SURRY TECHNICAL SPECIFICATION CHANGES

ENCLOSURE 3  
SAFETY EVALUATION FOR  
RESTORATION OF CONTROL ROD  
INSERTION LIMIT  
CURVES FOR SURRY UNIT 1

SURRY 1 TECHNICAL SPECIFICATION CHANGES

FIGURE 2.1-1 Reactor Core Thermal & Hydraulic Safety Limits  
Three Loop Operation, 100% Flow

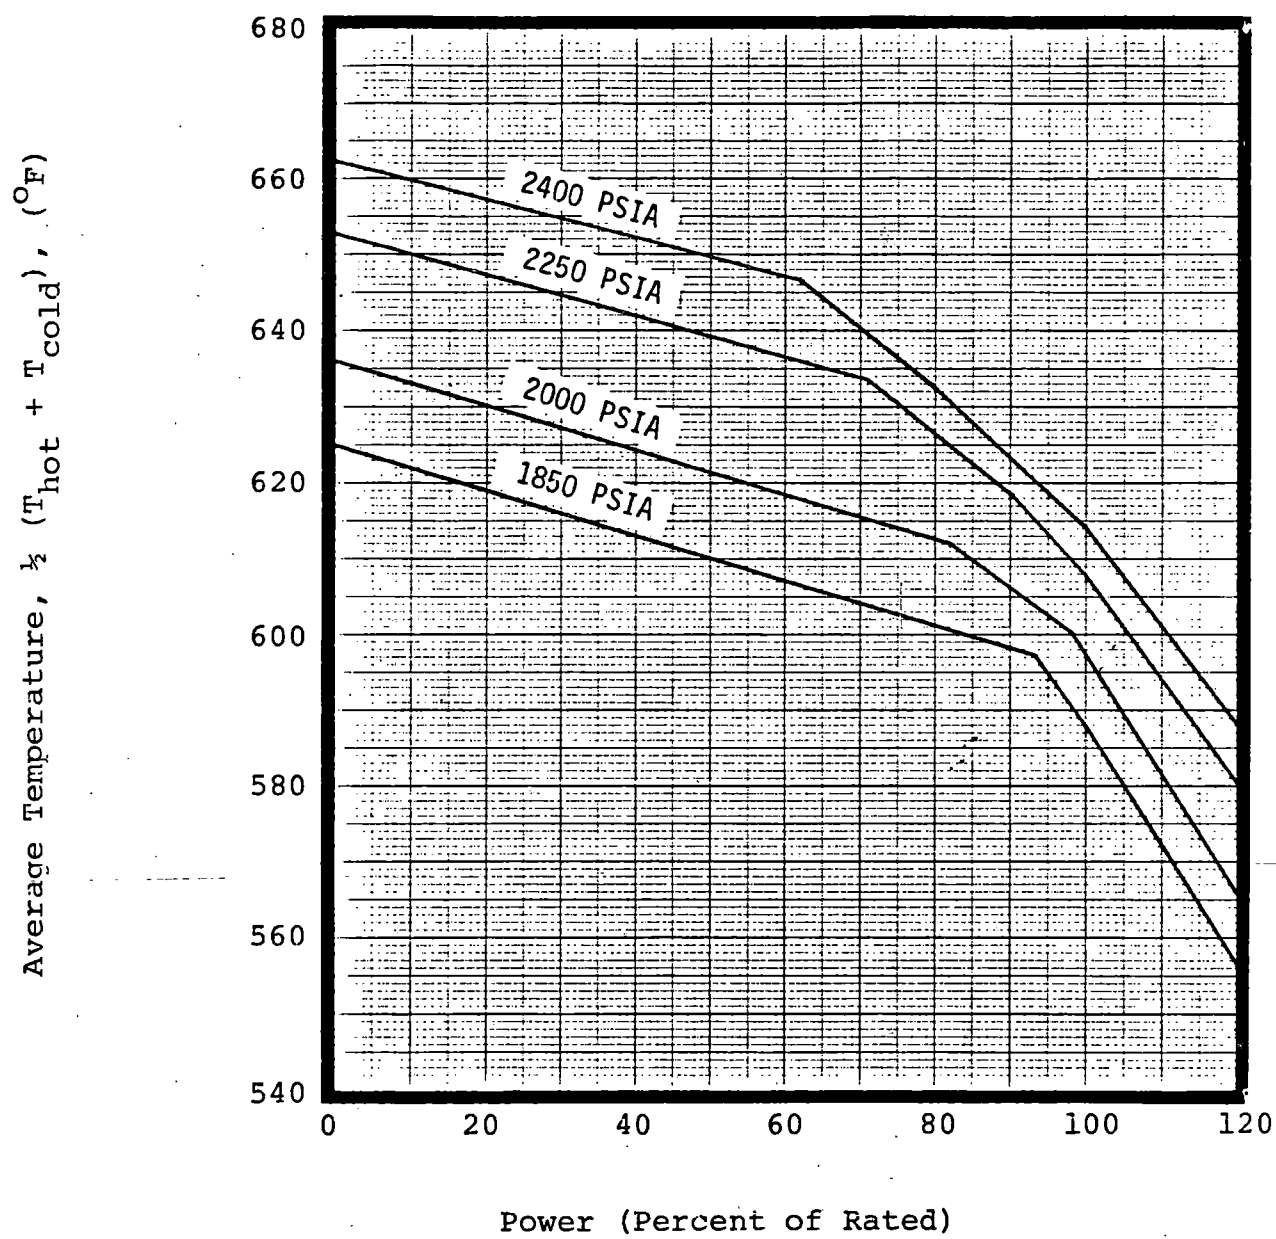
TS Figures 2.1-1 through 2.1-3 are based on a  $F_{DH}^N$  of 1.55, a 1.55 cosine axial flux shape and a DNB analysis procedure including the fuel densification power spiking <sup>(4)</sup> as part of the generic margin to accommodate rod bowing <sup>(5)(6)</sup>.

TS Figure 2.1-1 is also valid for the following limit of the enthalpy rise hot channel factor:  $F_{DH}^N = 1.55 (1 + 0.3 (1-P))$  where P is the fraction of rated power. TS Figures 2.1-2 and 2.1-3 include a 0.2 rather than 0.3 part power multiplier for the enthalpy rise hot channel factor.

FIGURE 3.12-1A CONTROL BANK INSERTION LIMITS FOR 3-LOOP  
NORMAL OPERATION-UNIT 1

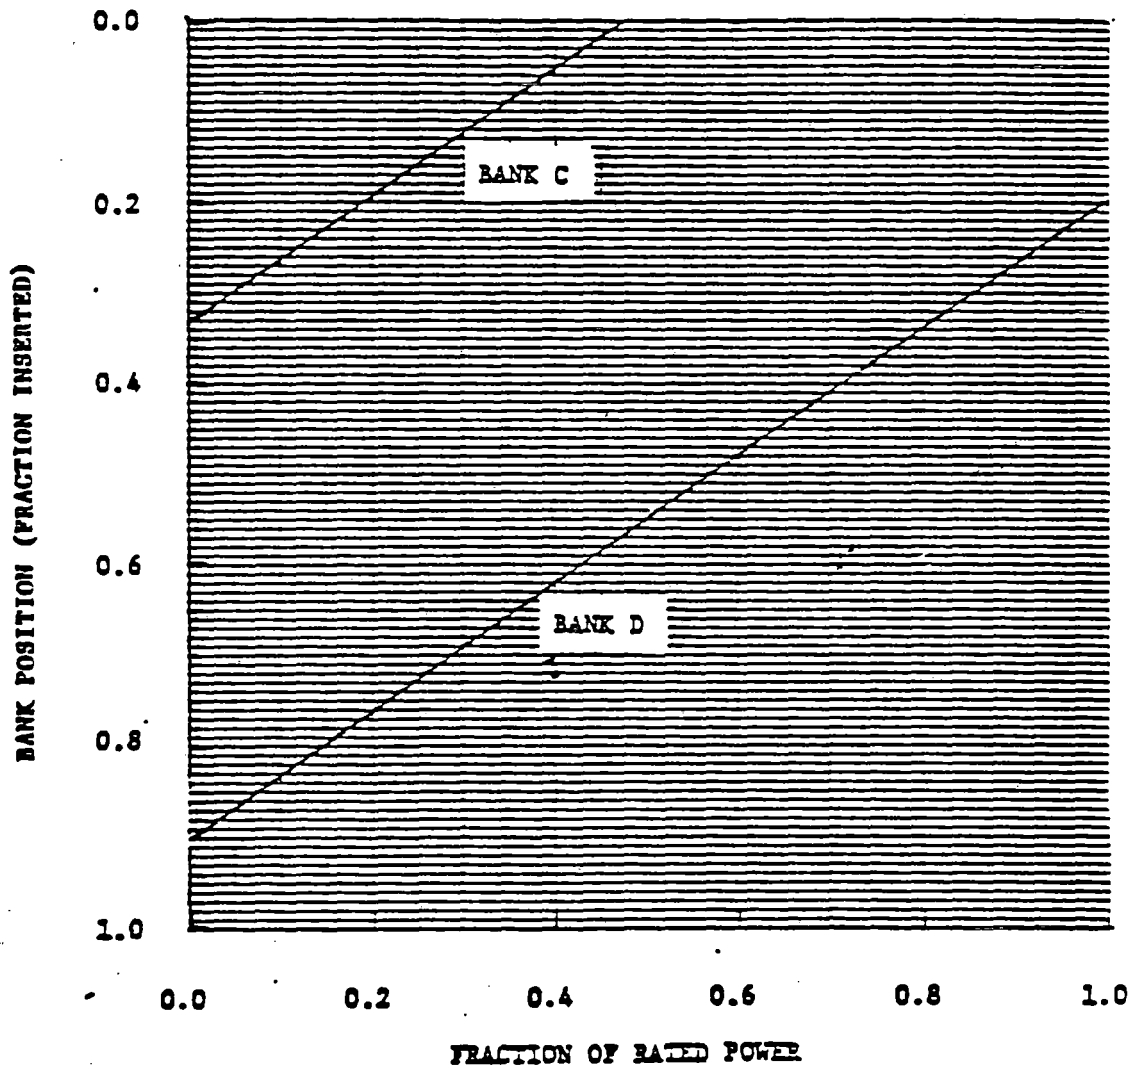
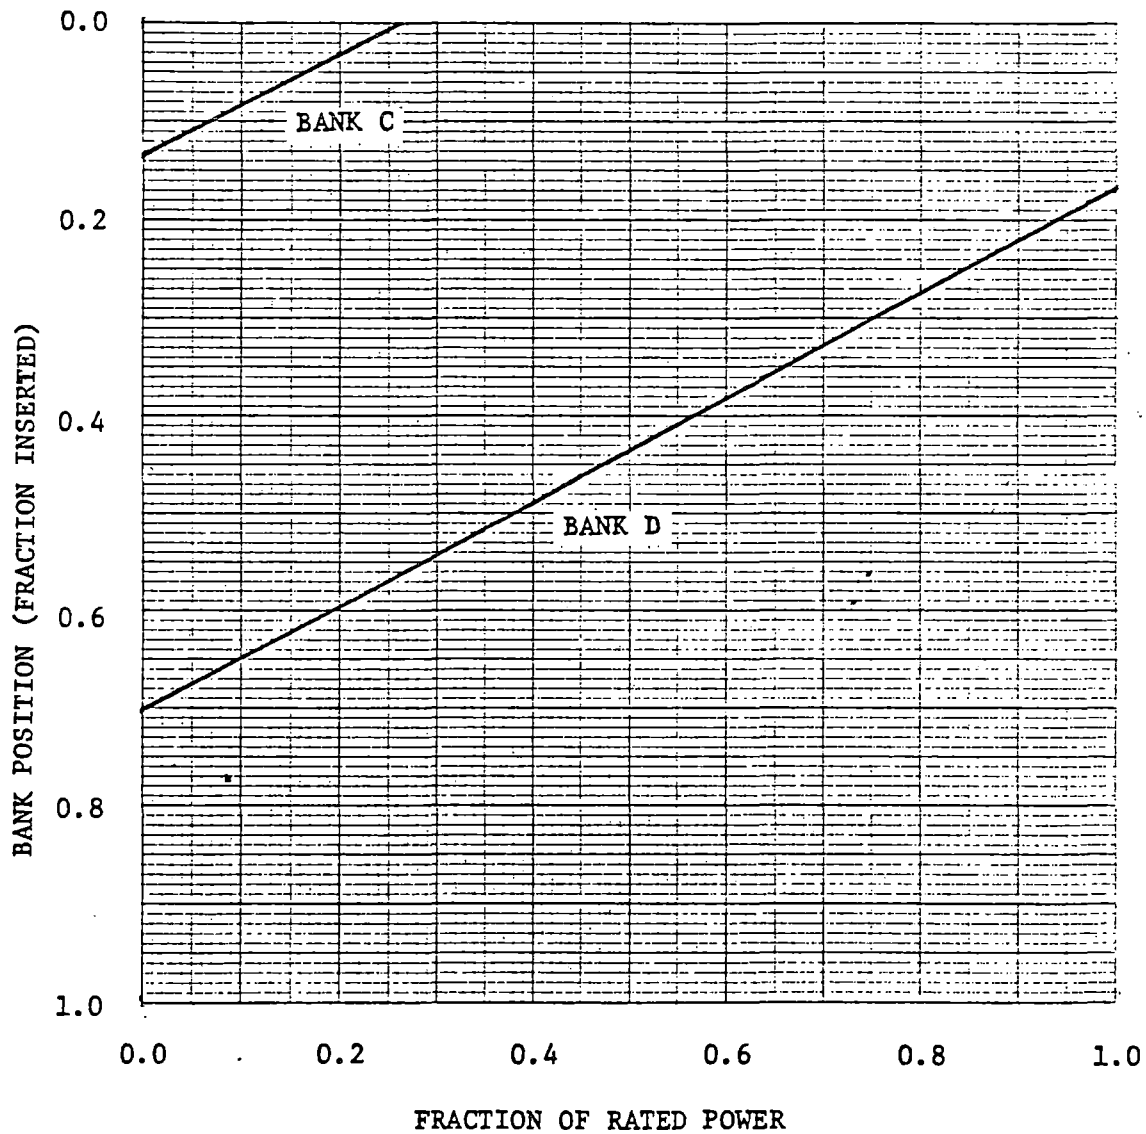
The Control Rod Insertion Limit Curves as defined in the Technical Specifications limit control rod insertion during power operations to maintain the following parameters within previously analyzed limits: trip reactivity, shutdown margin, ejected rod worth and radial power peaking factors. During Unit 1 Cycle 7 operations, the insertion limits were required to be raised from the previously established limits (Figure 1) to the revised limits of Figure 2. This change was required to maintain the radial power peaking factors ( $F_{\Delta H}^N$ ) below the Technical Specifications limits (i.e.,  $F_{\Delta H}^N \leq 1.55 (1.0 + 0.2(1-P))$  where  $P$  = fraction of rated thermal power). The reload safety evaluation of Unit 1 Cycle 7<sup>1</sup> stated that all safety-related core characteristics are within the bounds of current accident analysis assumptions for either the previously established or the revised insertion limits, except for  $F_{\Delta H}^N$ . The reload evaluation further established that, after 1000 MWD/MTU of Cycle 7 burnup, the radial peaking factors fall within the limits defined by the relationship

when the previously established limits of Figure 1 are assumed. This calculation of  $F_{\Delta H}^N$  versus power is depicted in Figure 3. Further, the Hot Zero Power peaking factors fall within these limits throughout Cycle 7 core life. Since it has been demonstrated<sup>2</sup> that these  $F_{\Delta H}^N$  limits are acceptable for Surry when applied in conjunction with an appropriate set of core thermal limits and overtemperature/overpower  $\Delta T$  setpoints, it is concluded that restoration of the Unit 1 rod insertion limits to the Figure 1 values after 1000 MWD/MTU of Cycle 7 operation does not result in an unreviewed safety question.

FIGURE 3.12-1A CONTROL BANK INSERTION LIMITS FOR 3-LOOP  
NORMAL OPERATION-UNIT 1

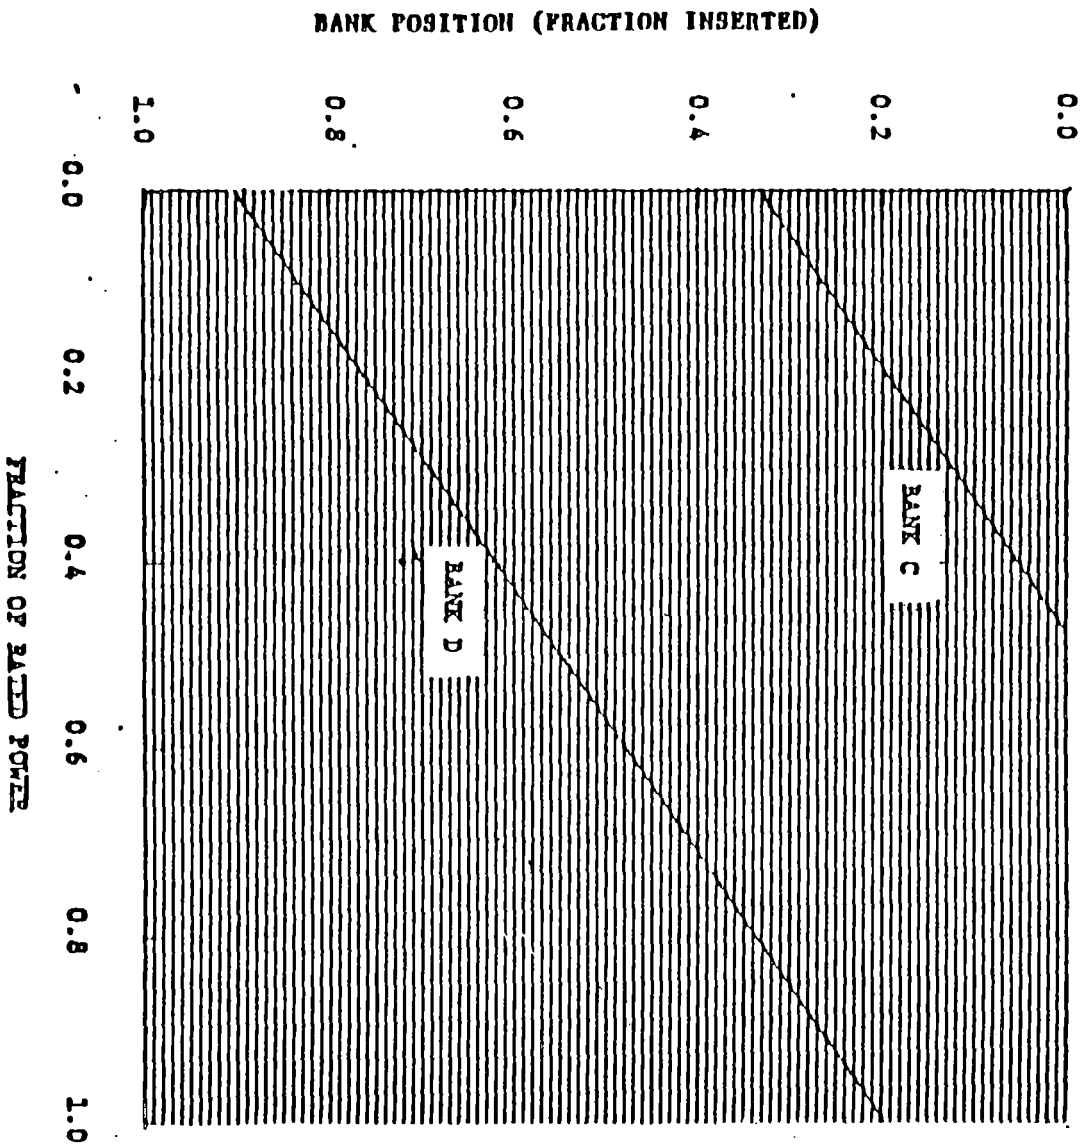
on the maximum inserted rod worth in the unlikely event of a hypothetical assembly ejection and provide for acceptable nuclear peaking factors. The limit may be determined on the basis of unit startup and operating data to provide a more realistic limit which will allow for more flexibility in unit operation and still assure compliance with the shutdown requirement. The maximum shutdown margin requirement occurs at end of core life and is based on the value used in the analysis of the hypothetical steam break accident. The rod insertion limits are based on end of core life conditions. The shutdown margin for the entire cycle length is established at 1.77% reactivity. All other accident analysis with the exception of the chemical and volume control system malfunction analysis are based on 1% reactivity shutdown margin. Relative positions of control rod banks are determined by a specified control rod bank overlap. This overlap is based on the consideration of axial power shape control. The specified control rod insertion limits have been established to limit the potential ejected rod worth in order to account for the effects of fuel densification. The various control rod assemblies (shutdown banks, control banks A, B, C, and D) are each to be moved as a bank; that is, with all assemblies in the bank within one step ( $5/8$  inch) of the bank position. Position indication is provided by two methods: a digital count of actuating pulses which shows the demand position of the banks, and a linear position indicator, Linear Variable Differential Transformer, which indicates the actual assembly position. The position indication accuracy of the Linear Differential Transformer is approximately  $\pm 5\%$  of span ( $\pm 12$  steps) under steady state conditions. The relative accuracy of the linear position indicator has been considered in establishing the maximum allowable deviation of a control rod assembly from its indicated group step demand position. In the event that the linear position indicator is not
